ADDENDUM NO. 02
TO THE CONSTRUCTION DOCUMENTS BID PACKAGE

Client: Arrowhead Regional Medical Center
Project: Oncology-Ambulatory Clinic
SHA Project No.: 18242.100
Date: September 12, 2019

ARROWHEAD REGIONAL MEDICAL CENTER M.O.B. ONCOLOGY-AMBULATORY CLINIC

A111

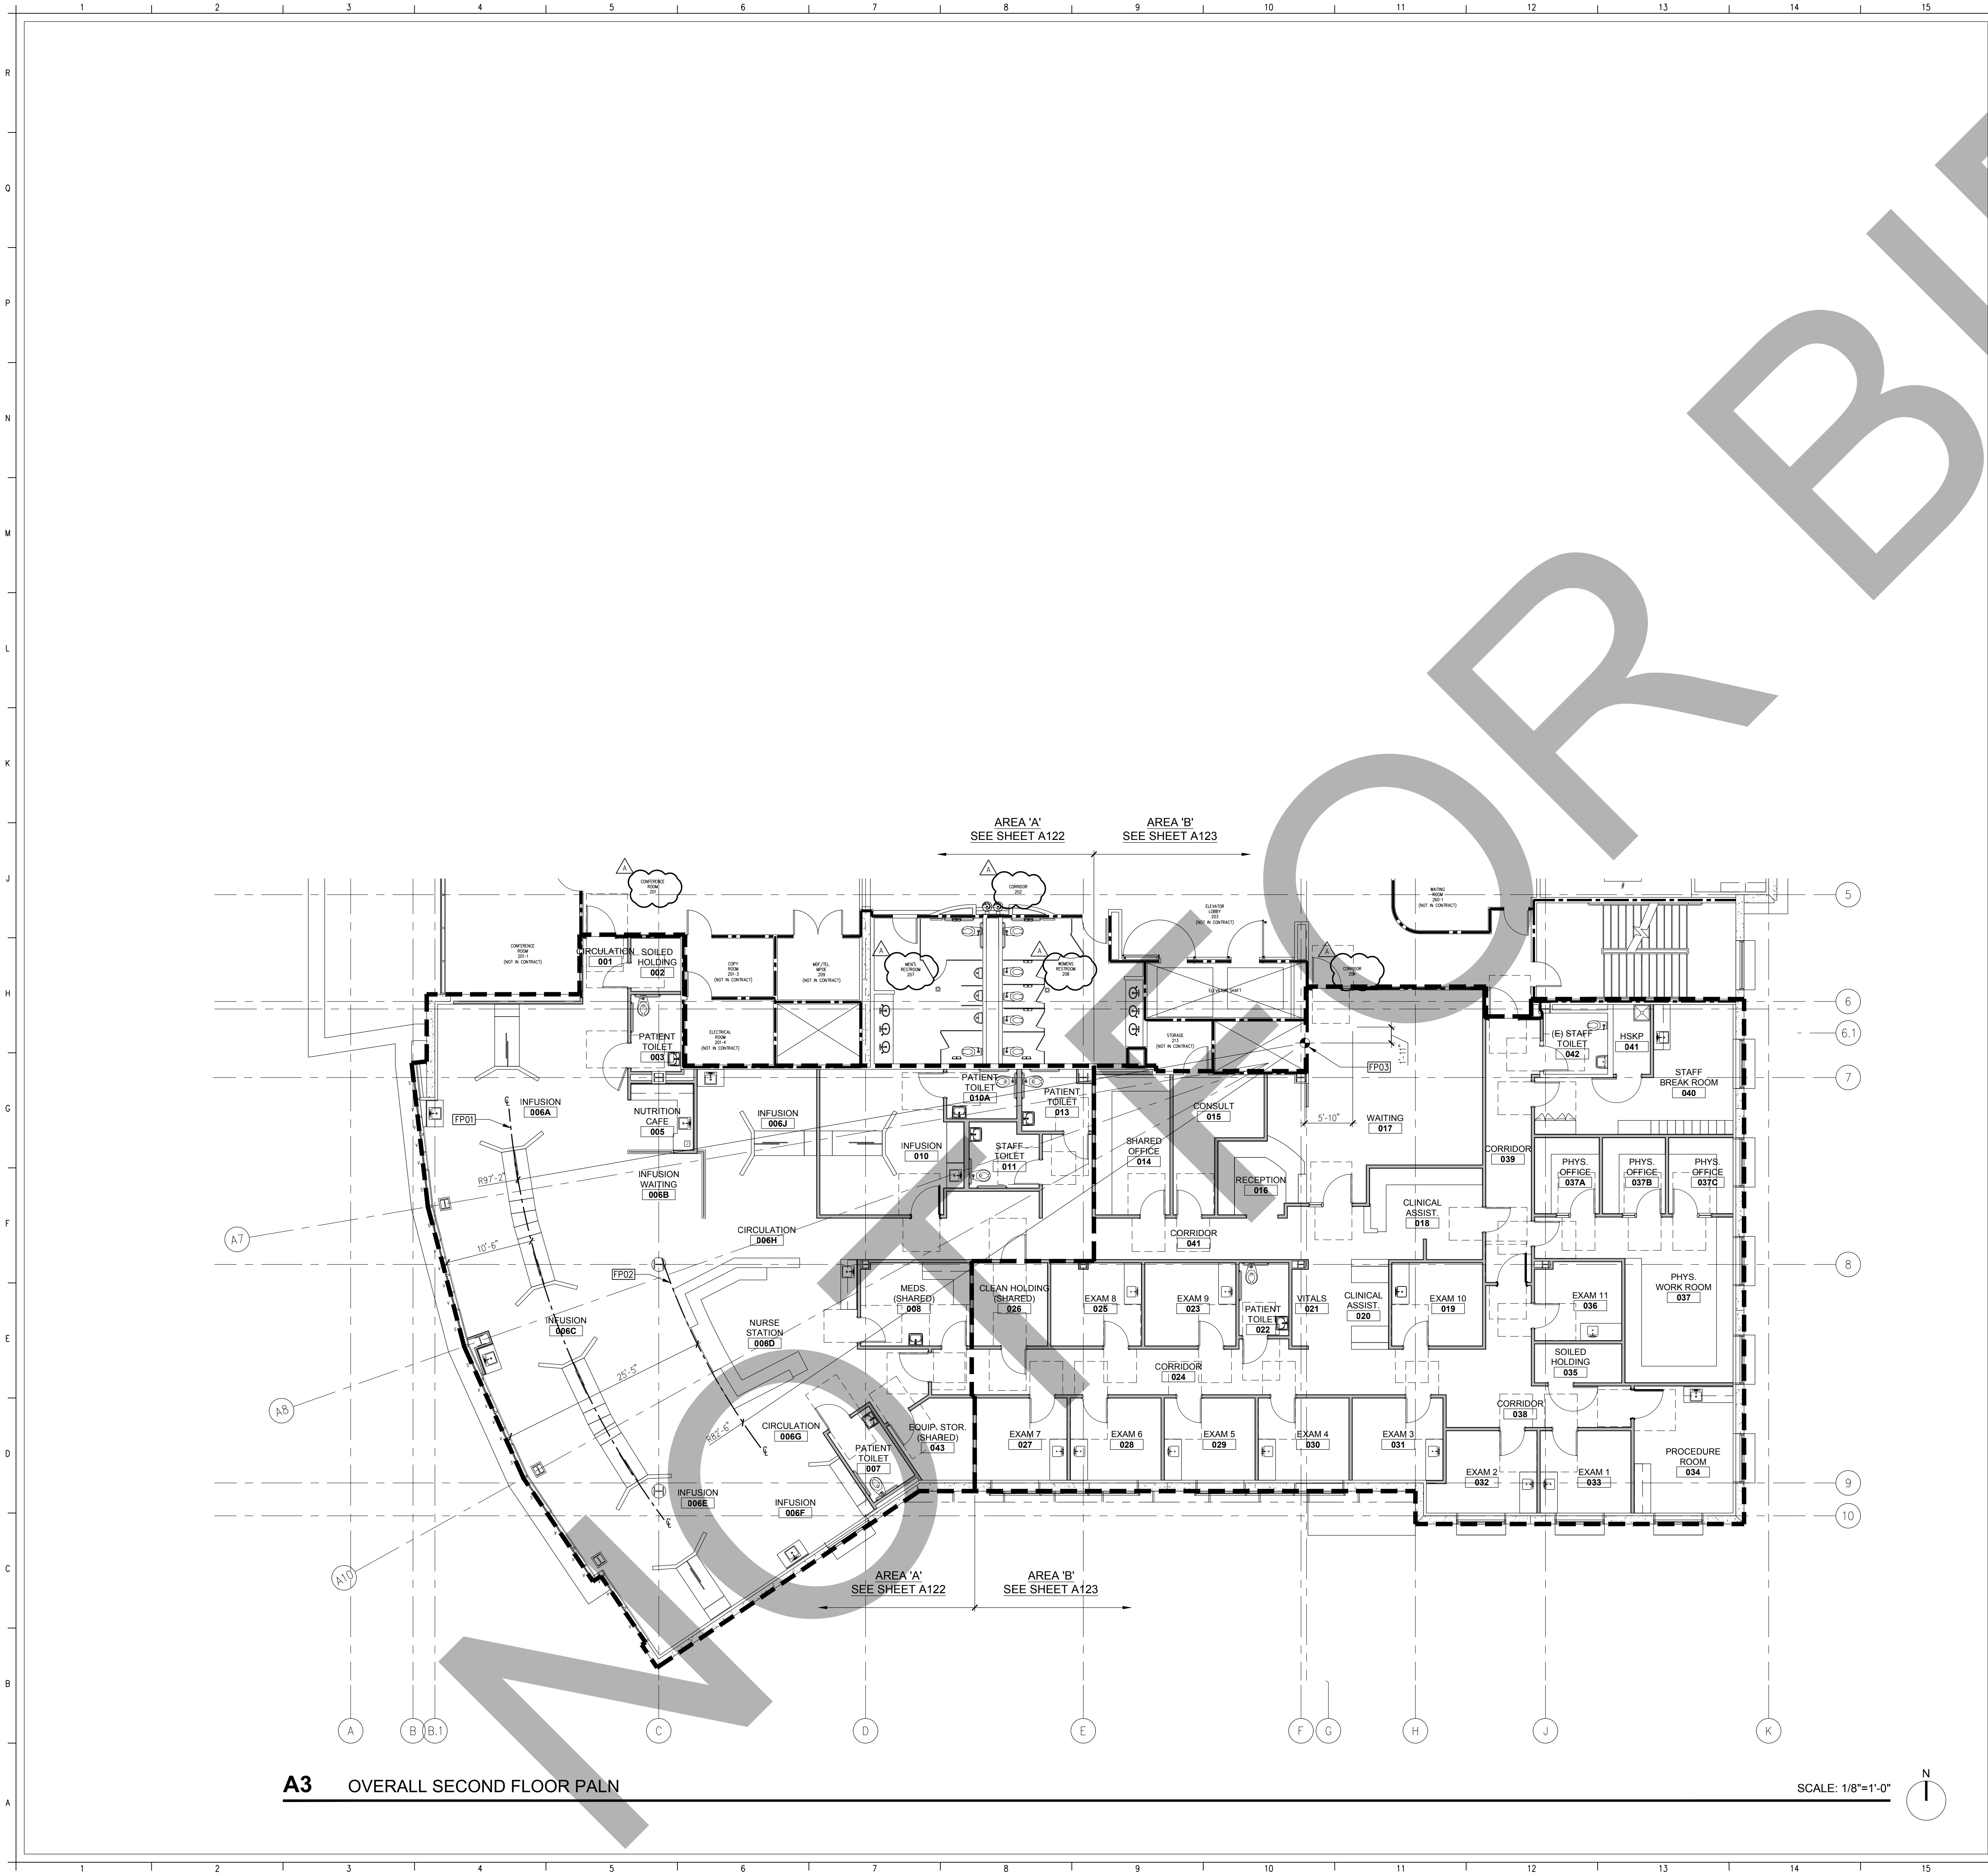
A111 Existing room names added to the corridor that is to the north of the project area, scope revised to indicate partial demolition of the ceiling in this corridor.

General Note added to sheet regarding accommodations for equipment or material deliveries and trash removal from the project area.

A121

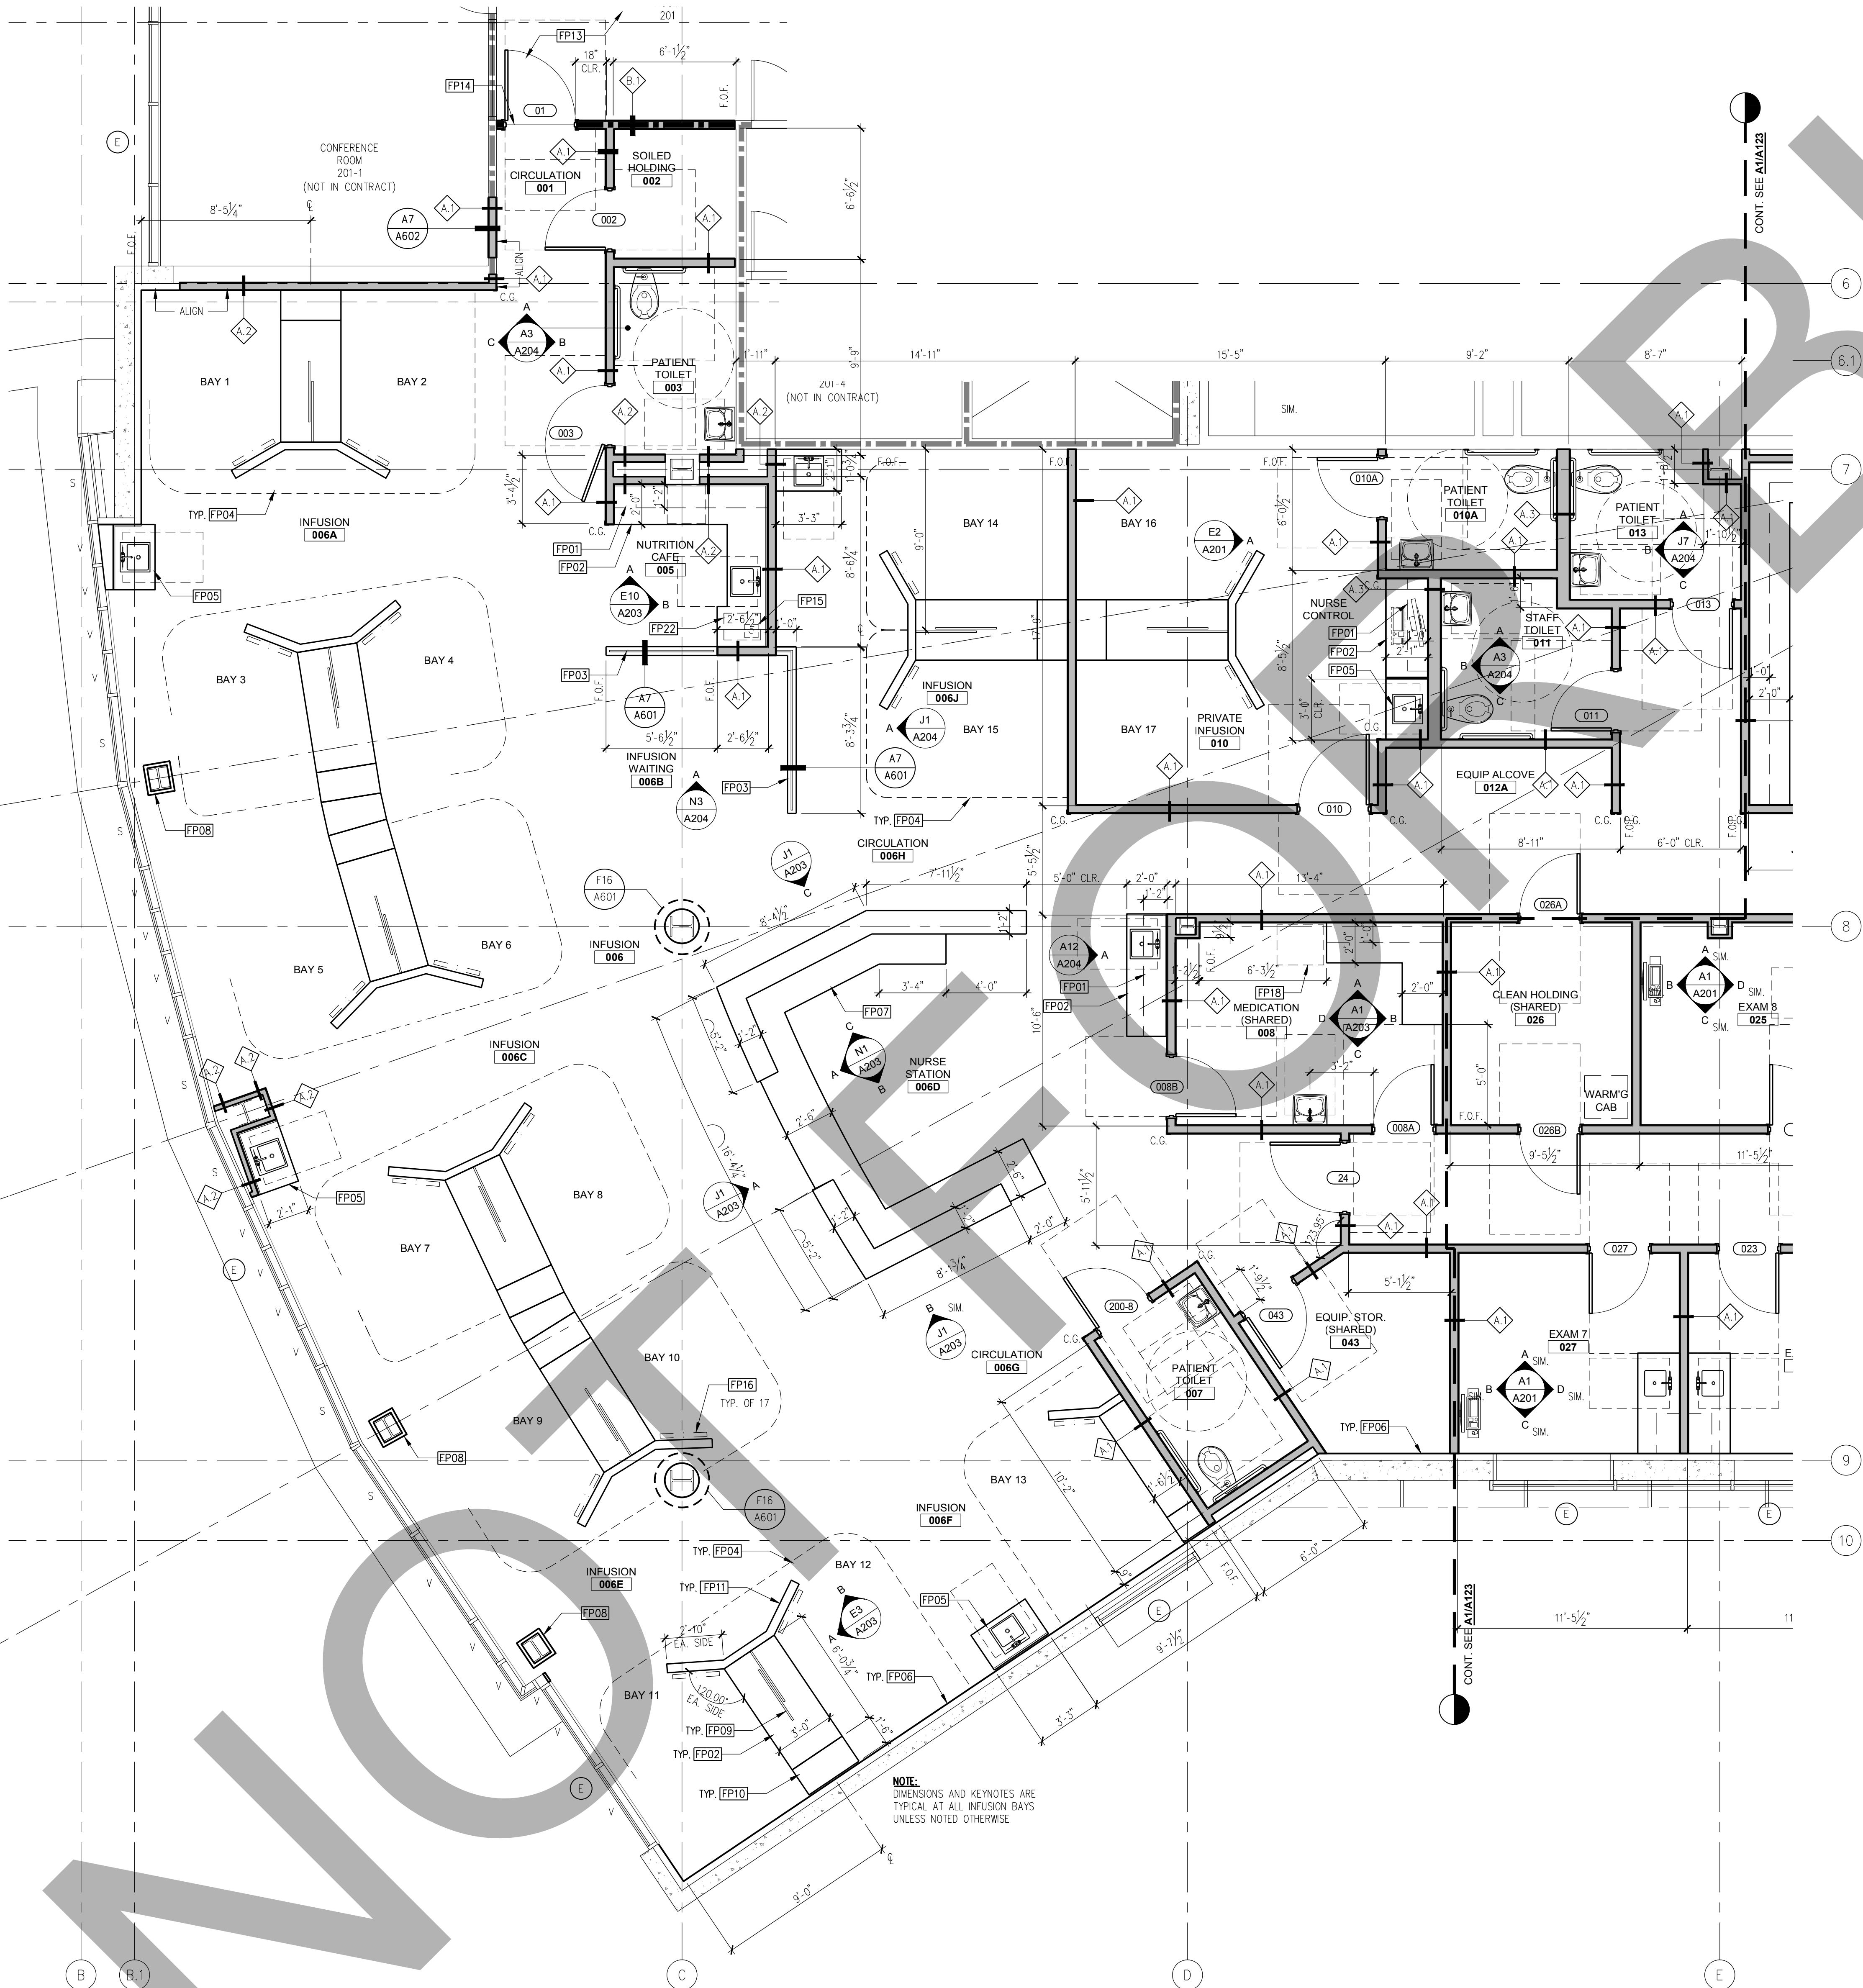
A121 Removed "NOT IN CONTRACT" from room identification tags in rooms that require partial ceiling demolition.

A123

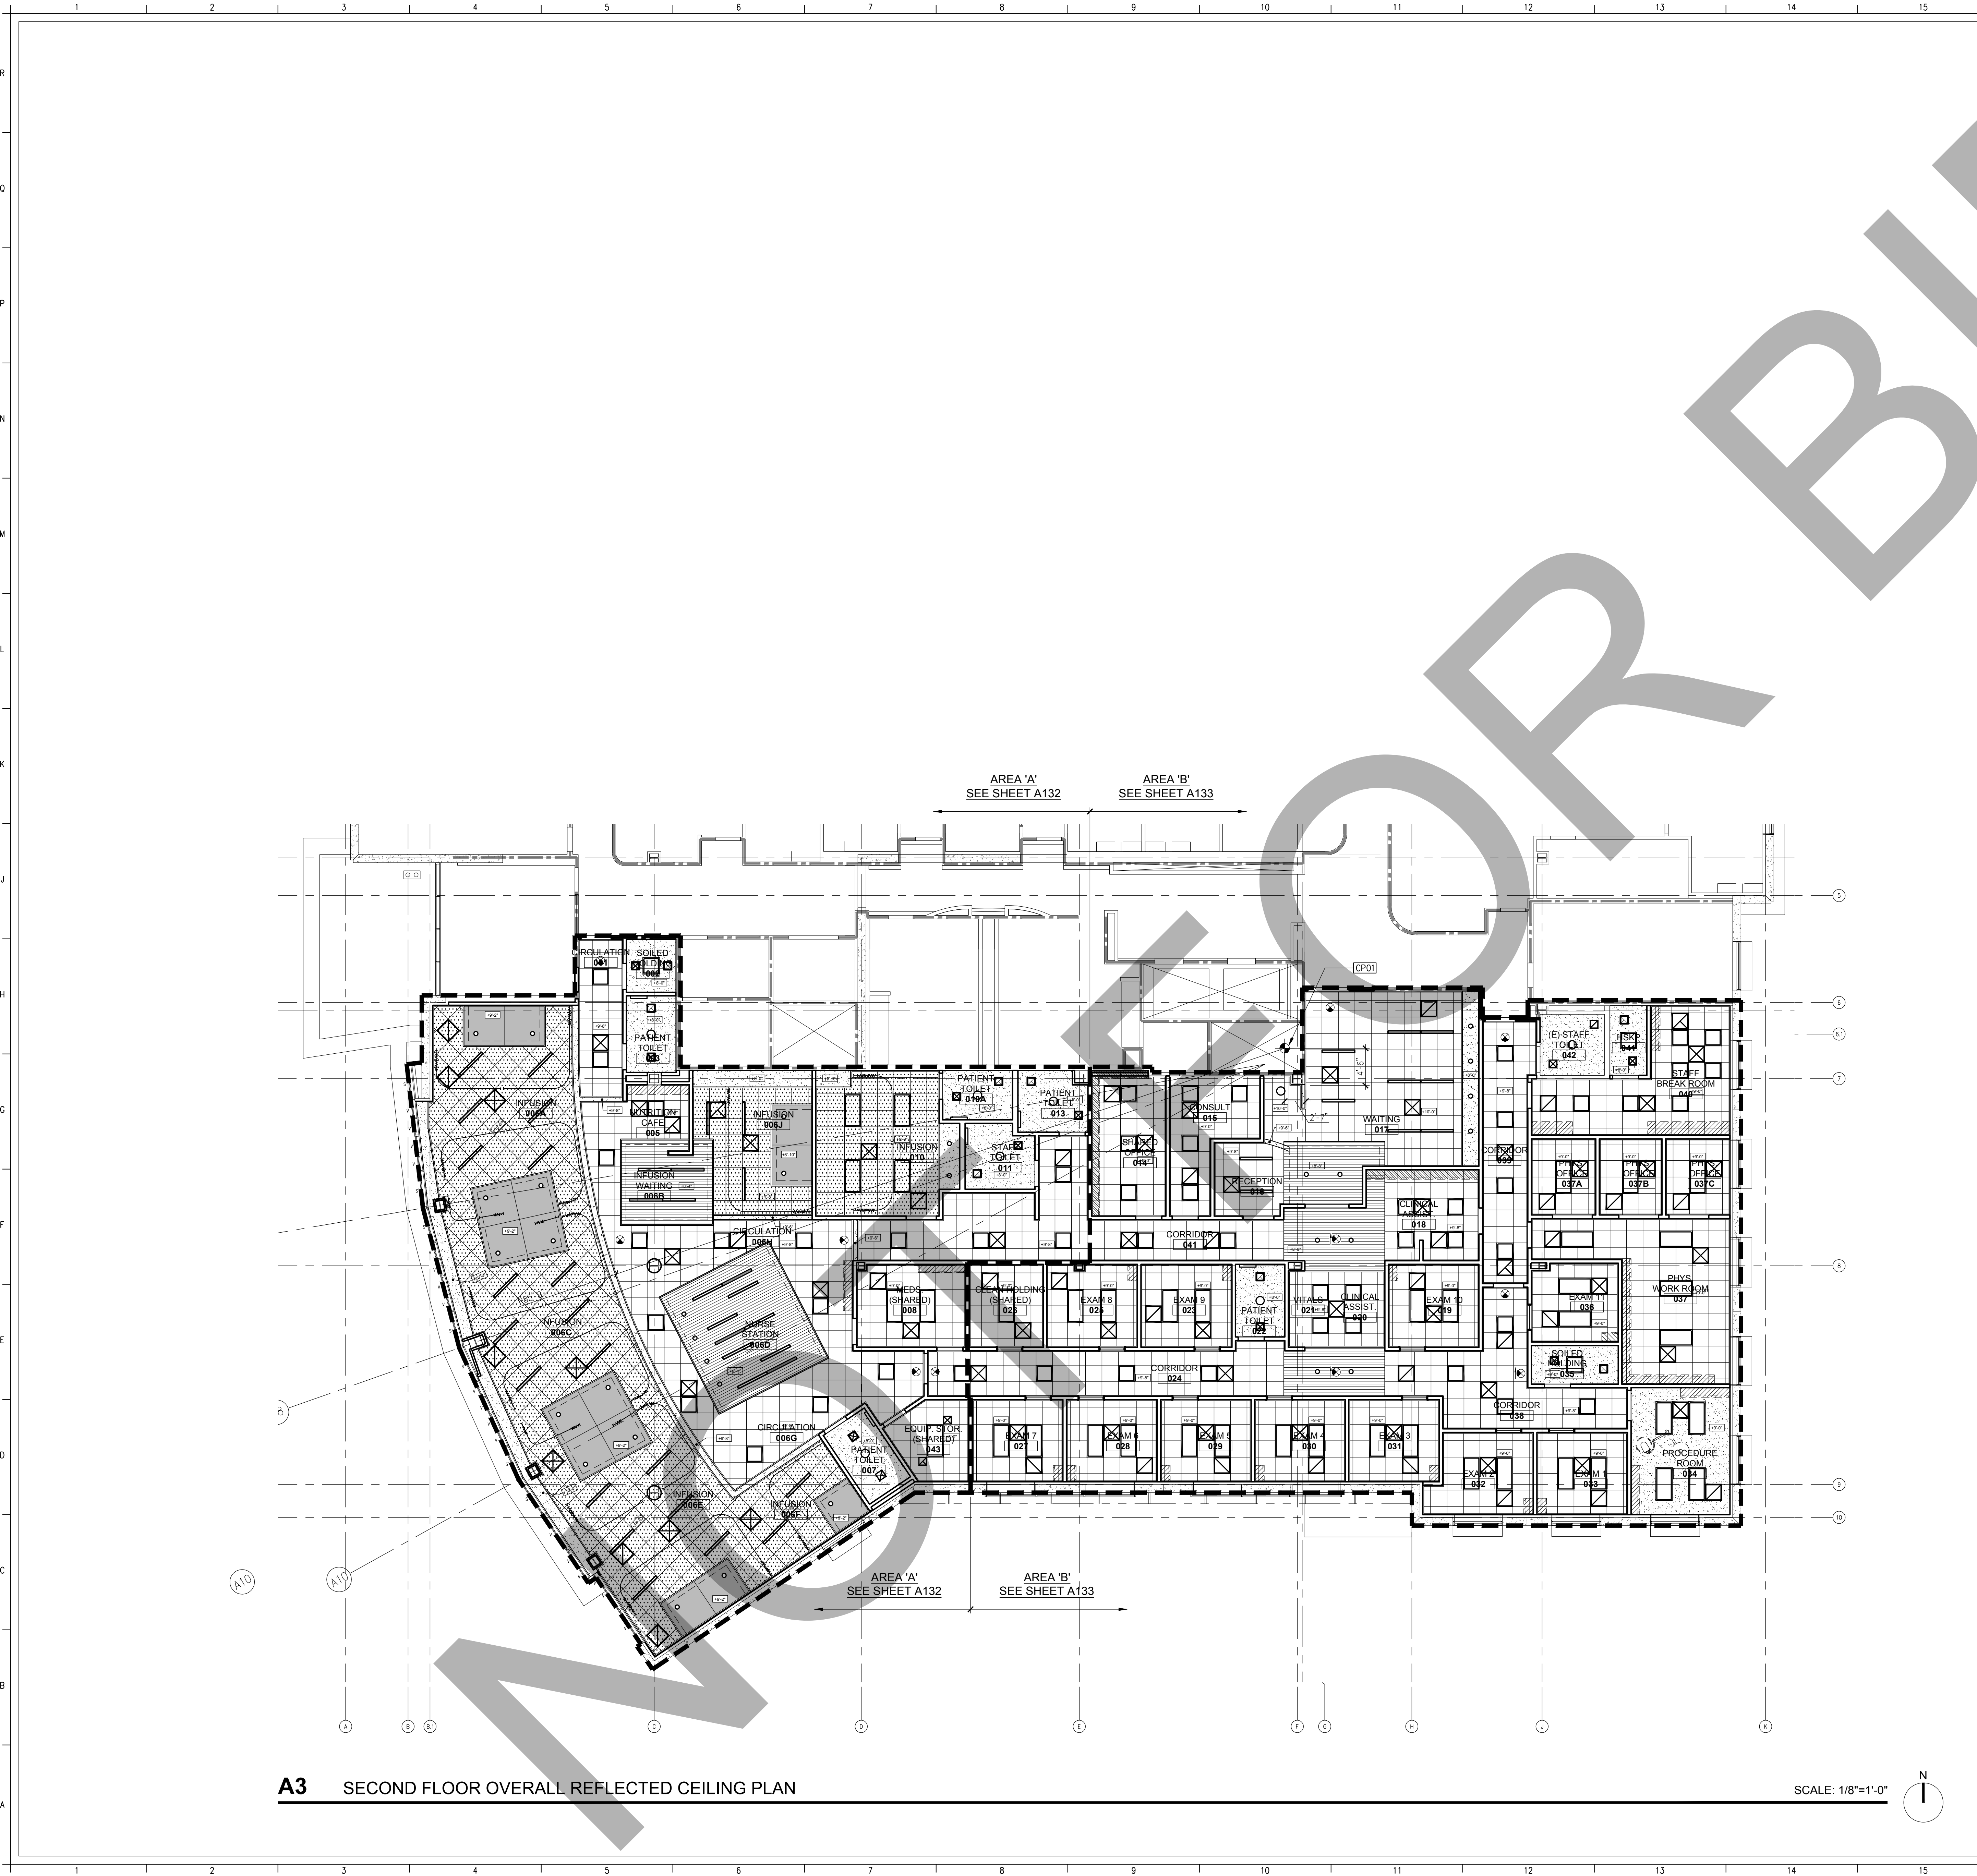
- A123** Keynote FP06 revised to indicate new gypsum board at existing framing.
- A131** General Note added to sheet regarding patching back of existing ceilings in corridor.
General Note regarding Owner Furnished Items added to General Notes.

ALL EXISTING CEILINGS DEMOLISHED AS REQUIRED BY NEW WORK SHALL BE PATCHED, REPAIRED AND FINISHED TO MATCH EXISTING AND ADJACENT SURFACES
